# Airworthiness Directives; Sikorsky Aircraft Corporation Helicopters

**ACTION:** Notice of proposed rulemaking (NPRM).

**SUMMARY:** We propose to revise airworthiness directive (AD) 2014-12-11 for Sikorsky Aircraft Corporation (Sikorsky) Model S-92A helicopters. AD 2014-12-11 currently requires revising the Rotorcraft Flight Manual (RFM) to include the appropriate operating limitations for performing Class D external load-combination operations. As published, AD 2014-12-11 references an incorrect date for Revision No. 12 of Sikorsky RFM SA S92A-RFM-003, Part 1. This proposed AD would correct the error while retaining the requirements of AD 2014–12–11. These proposed actions are intended to require appropriate operating limitations to allow operators to perform Class D external load-combination operations, including human external cargo, in this model helicopter that now meets the Category A performance standard.

Sikorsky Aircraft Corporation: Docket No. FAA–2009–1088; Directorate Identifier 2008–SW–76–AD.

Figure 1 to Paragraph (f)(3)(iii)

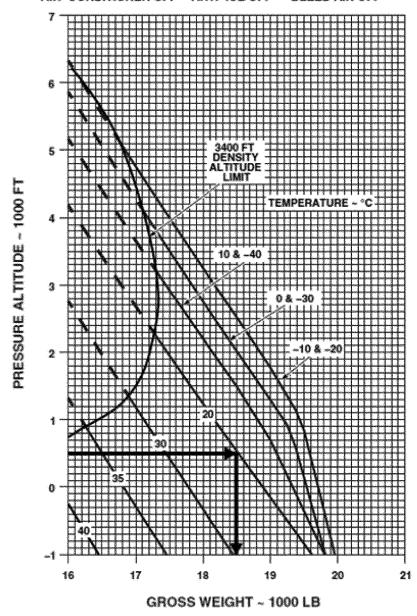
(iii) Add the following and insert Figure 1 to Paragraph (f)(3)(iii) of this AD: ""HOIST" Maximum gross weight for Human External Cargo, which requires category 'A' performance capabilities, is limited to the gross weight determined in accordance with the following Figure 1 to Paragraph (f)(3)(iii) of this AD for your altitude and temperature with the air-conditioner, anti-ice, and bleed air turned off."

Note 1 to paragraph (f)(3)(iii) of this AD: Figure 1 to Paragraph (f)(3)(iii) of this AD becomes Figure 1–2A when inserted in the "Weight Limits" section of your RFM.
